**ADDENDUM NO. 5  
TO  
Natomas Mutual Water Company  
American Basin Fish Screen & Habitat Improvement Project  
Sankey Diversion and Canal Facilities**

This Addendum No. 5 consists of 12 pages plus Exhibits A through G as described in the Exhibits Table of Contents following Page 5-12 of the Addendum. It is the responsibility of the Bidder to assure and guarantee by acknowledging the receipt of this Addendum in the Bid Form that the Bidder has received the addendum in its entirety, and that the Bidder accepts all conditions contained herein.

**EXHIBIT D**  
**Volume 3**  
**Schedule A**  
**Revised Contract Drawing SNK-YP-3**

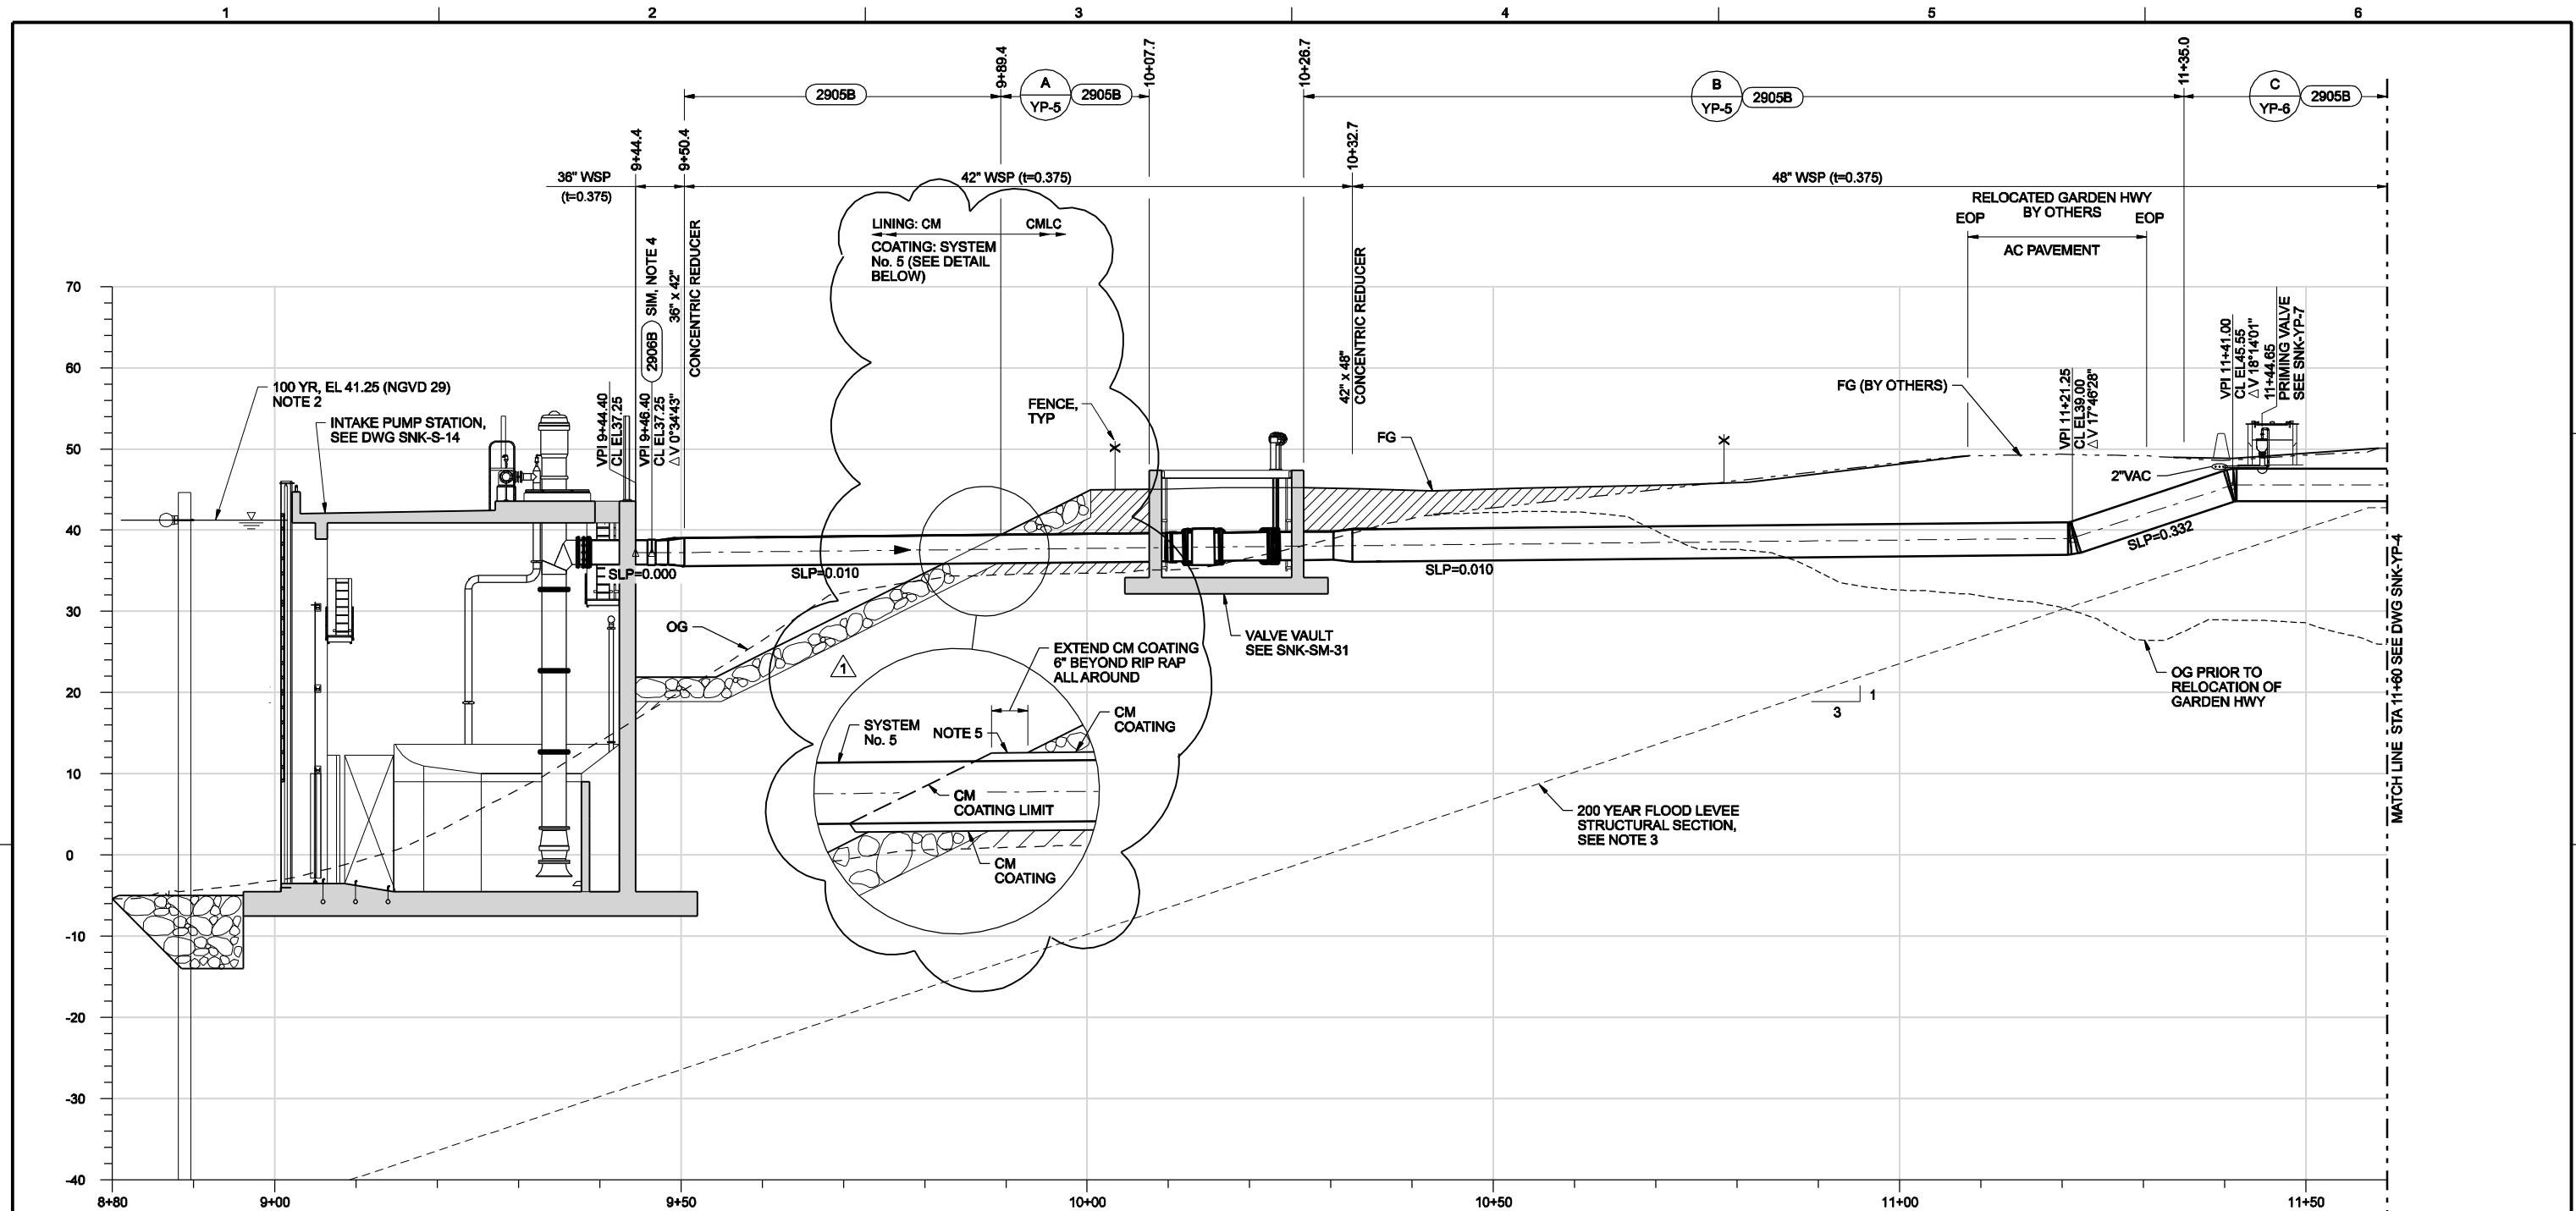
17. DRAWING NUMBER SNK-YP-3 – DISCHARGE PIPING PROFILE

Delete Drawing No. SNK-YP-3 in its entirety and replace it with revised Drawing No. SNK-YP-3 as contained in Exhibit D of this Addendum No. 5.

CIVIL  
SCHEDULE B - SANKEY CANAL FACILITIES  
PLAN & PROFILE - STA 13+00 TO 28+00

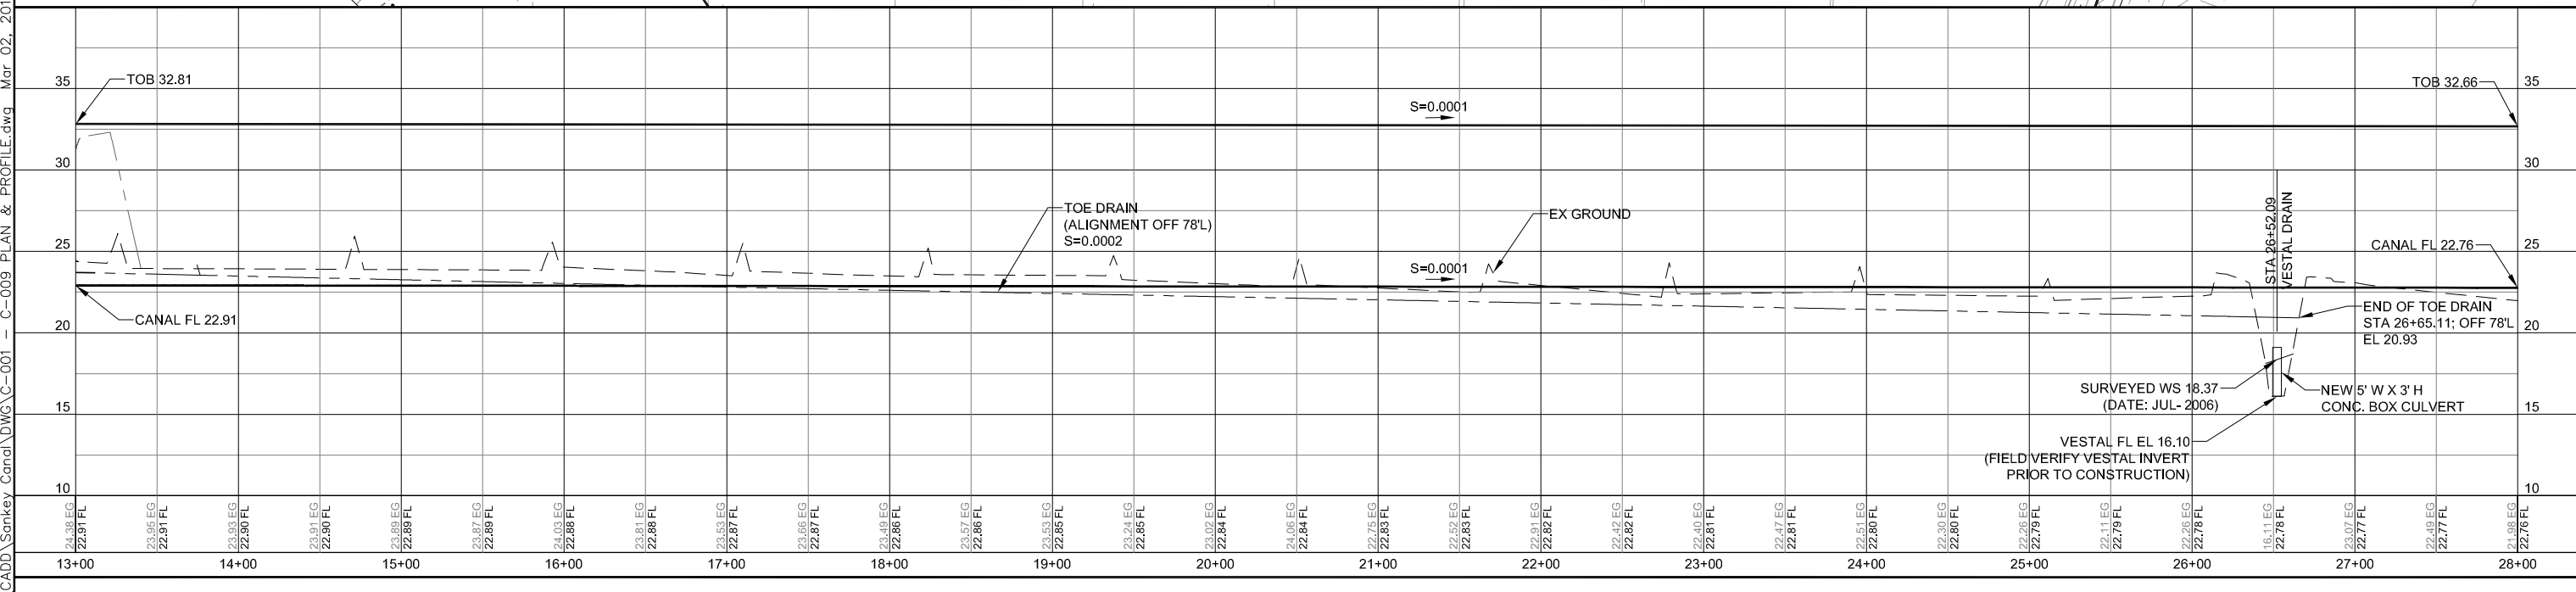
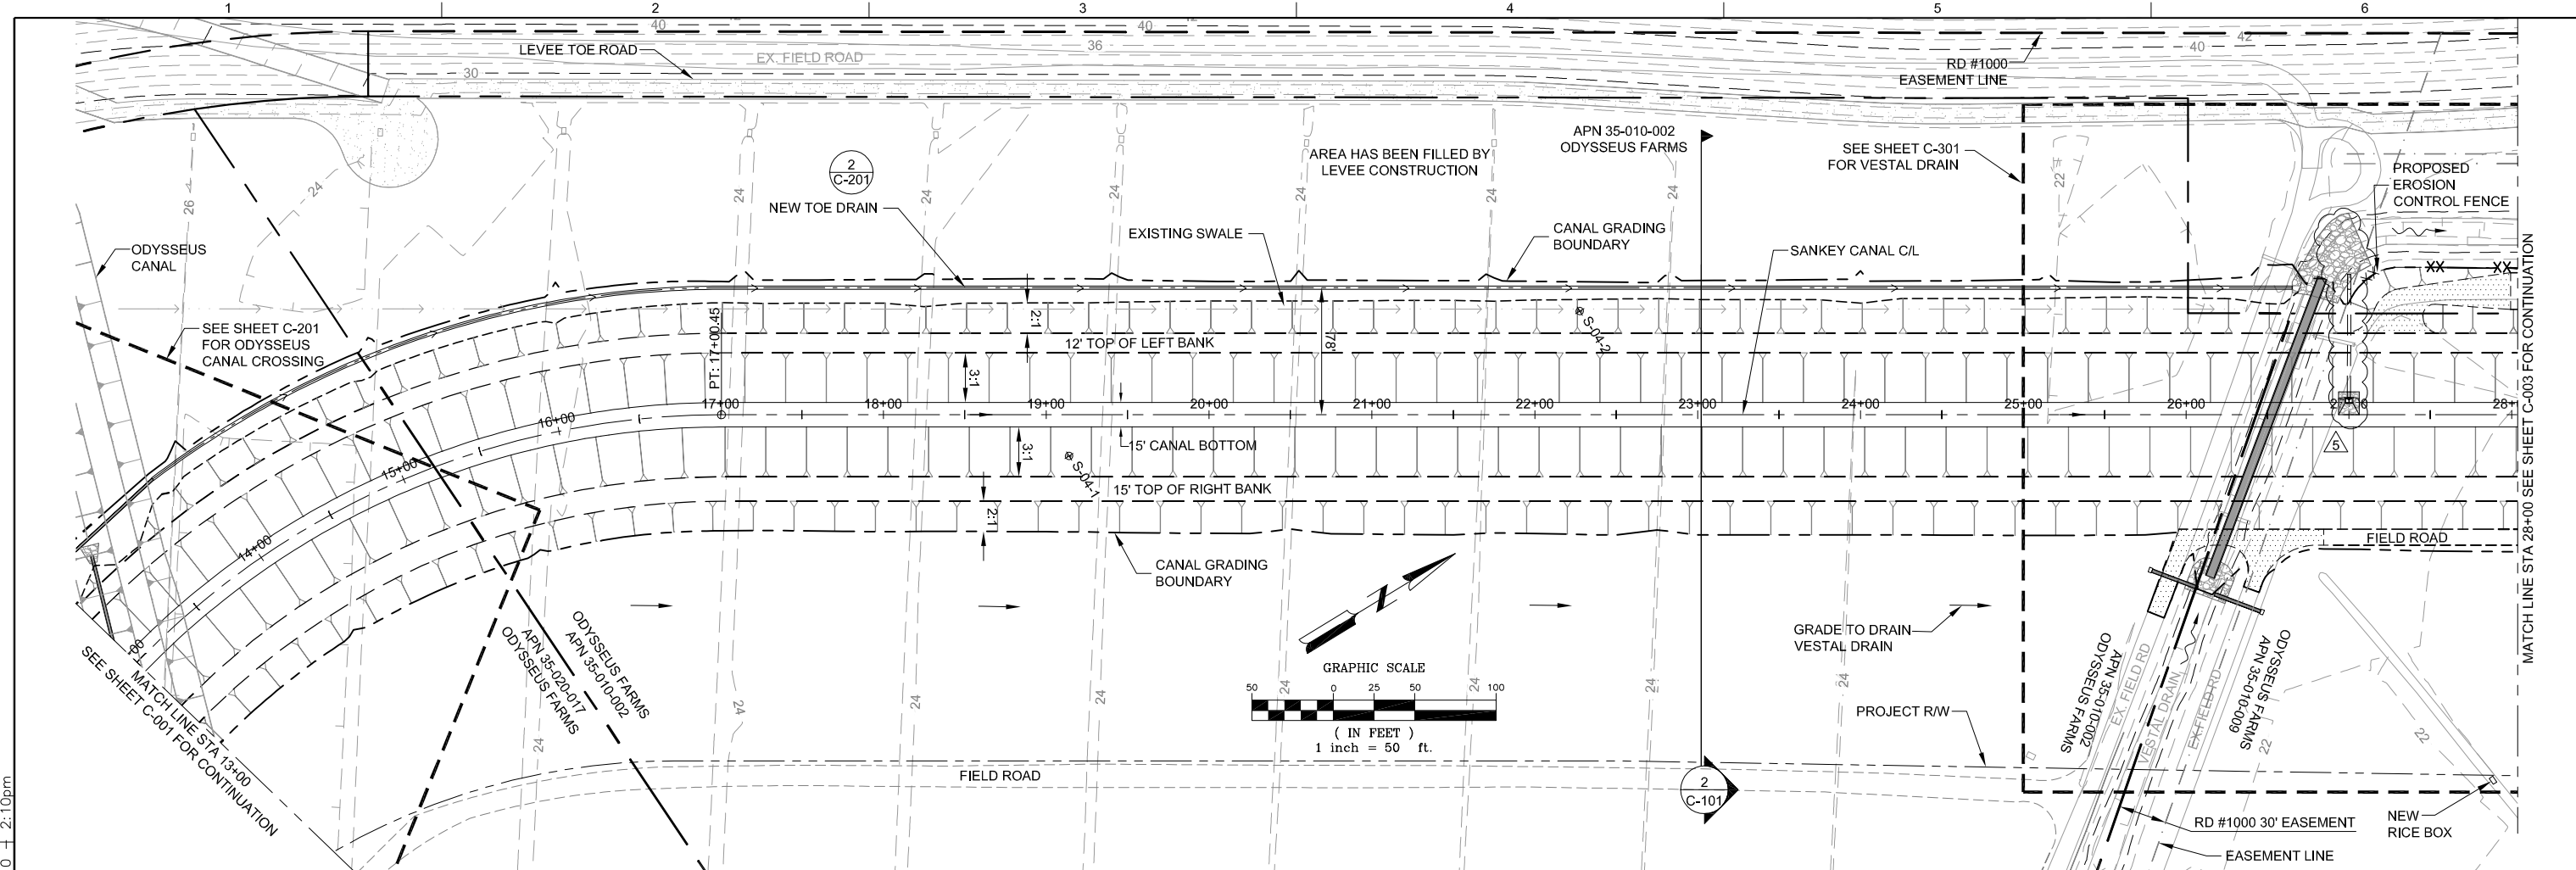
29. DRAWING NUMBER C-002 – PLAN & PROFILE STA 13+00 TO 28+00

Delete Drawing No. C-002 in its entirety and replace it with revised Drawing No. C-002 as contained in Exhibit E of this Addendum No. 5.

**EXHIBIT F**  
**Volume 5**  
**Schedule B**  
**Revised Contract Drawing C-301**

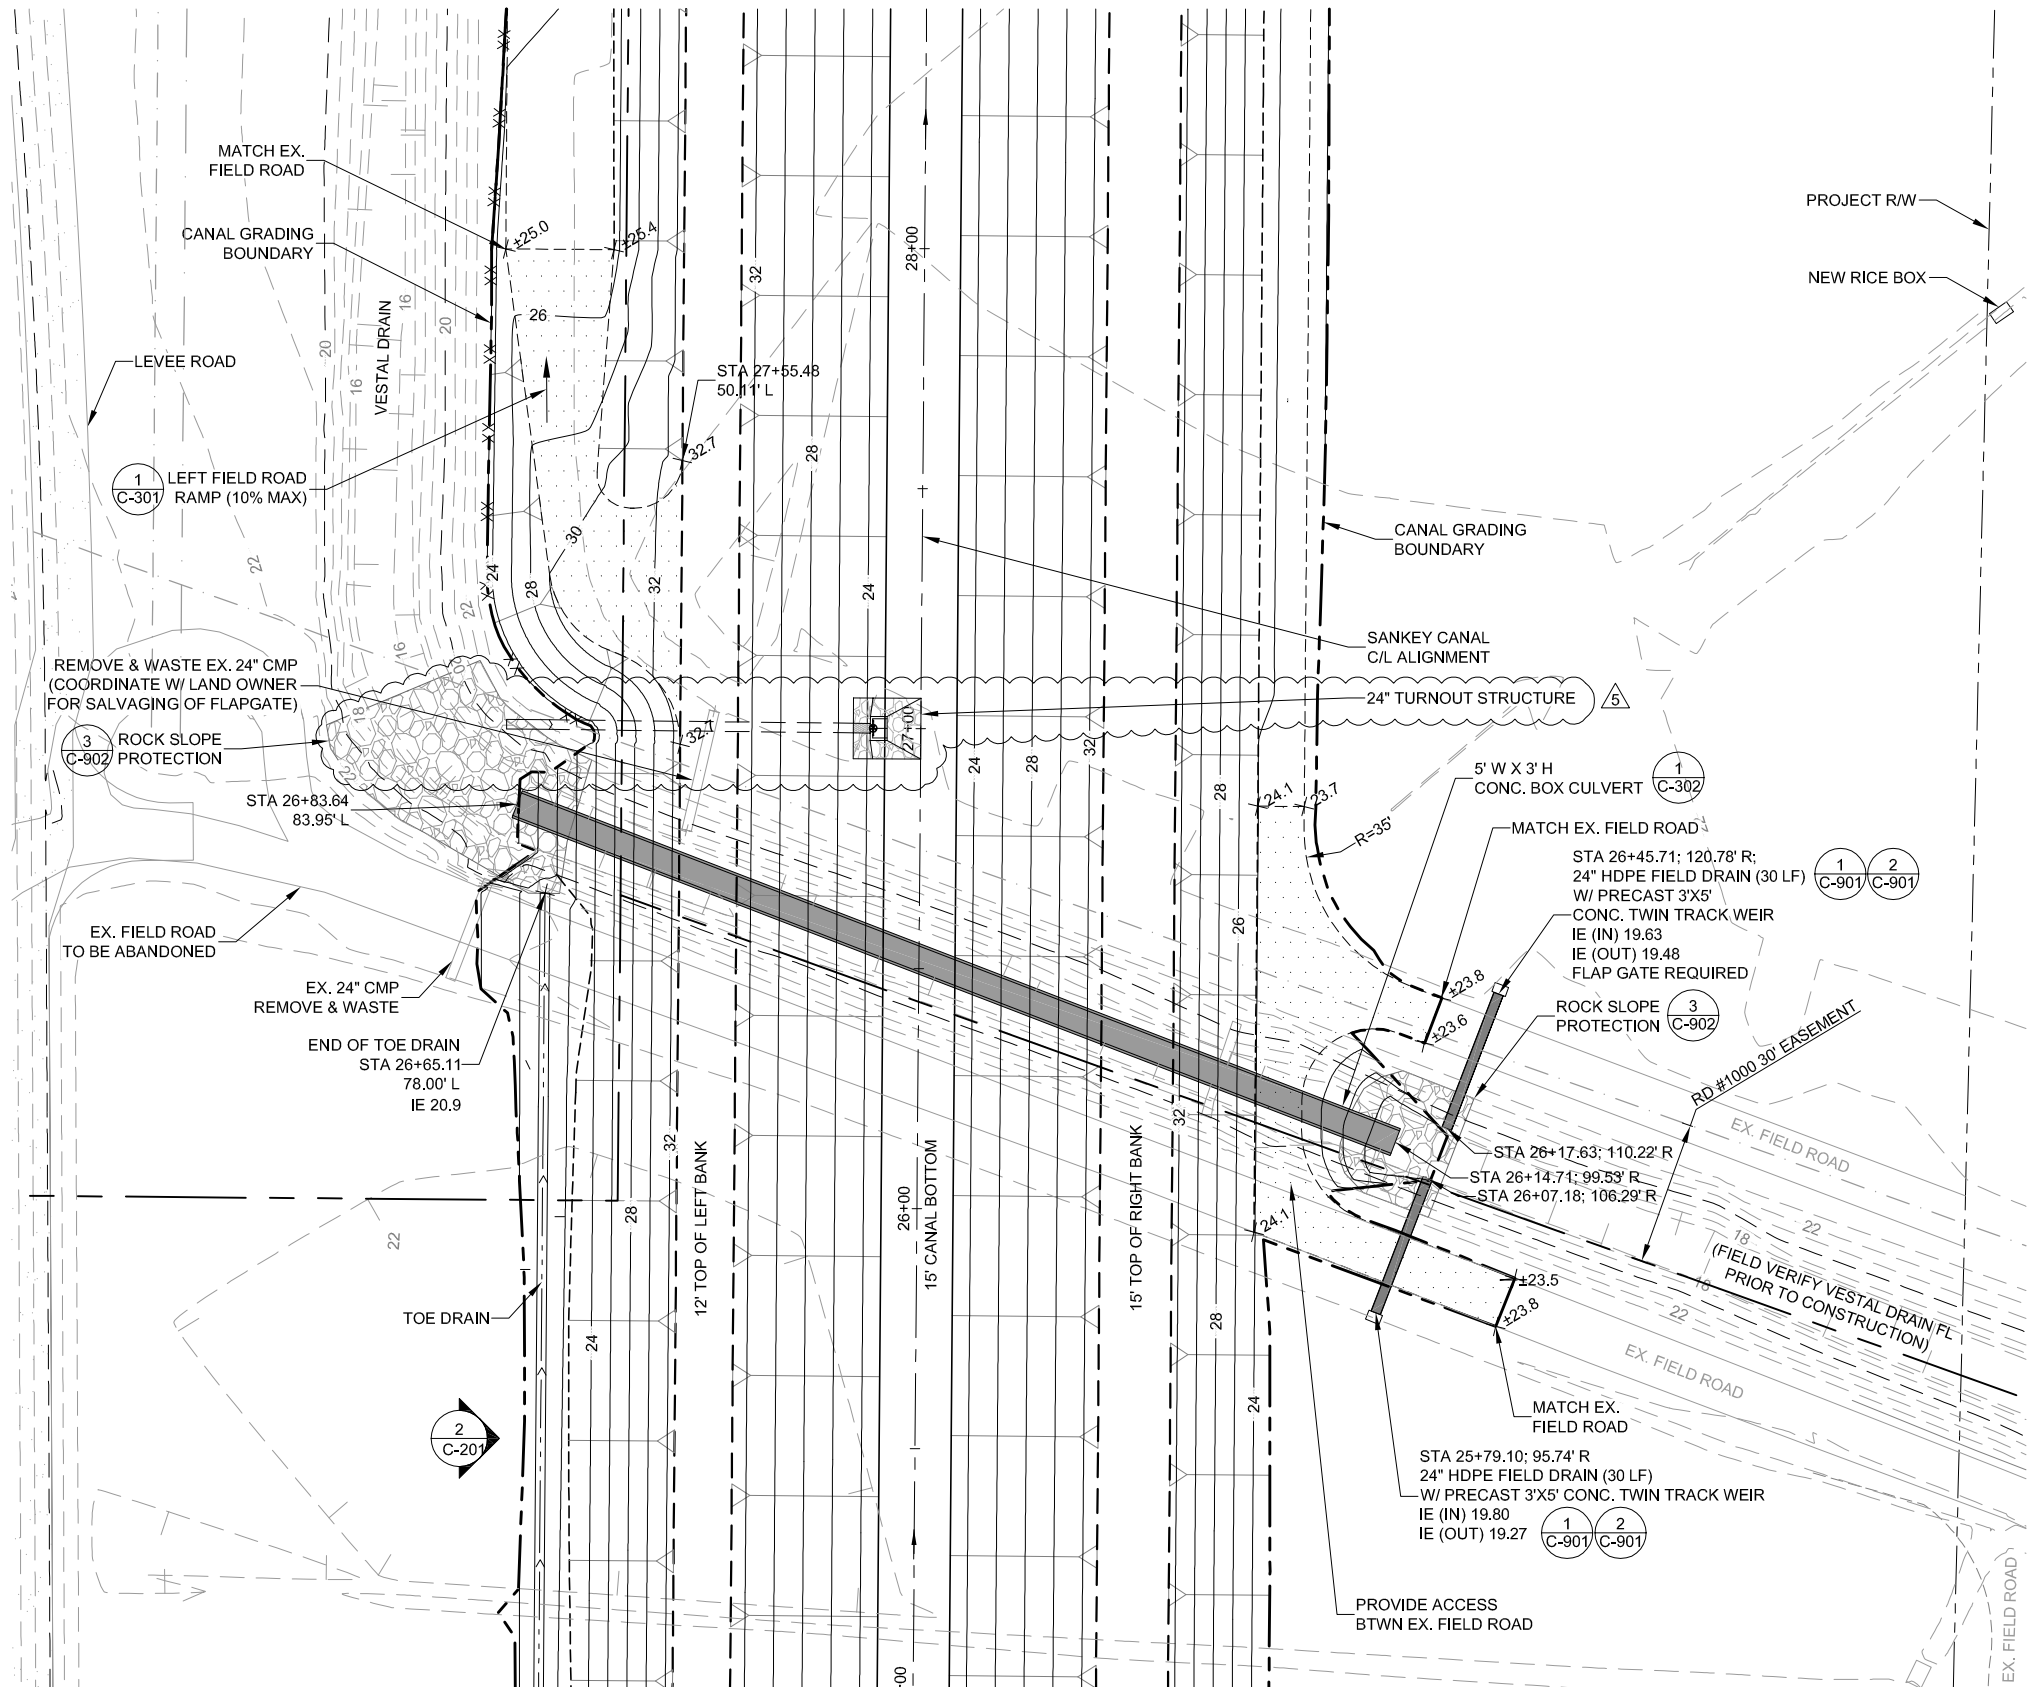
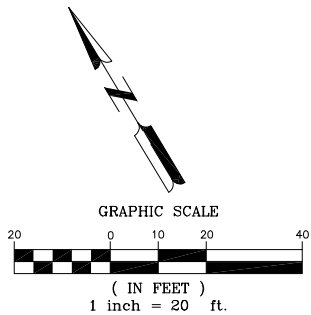
30. DRAWING NUMBER C-301 – VESTAL DRAIN

Delete Drawing No. C-301 in its entirety and replace it with revised Drawing No. C-301 as contained in Exhibit F of this Addendum No. 5.
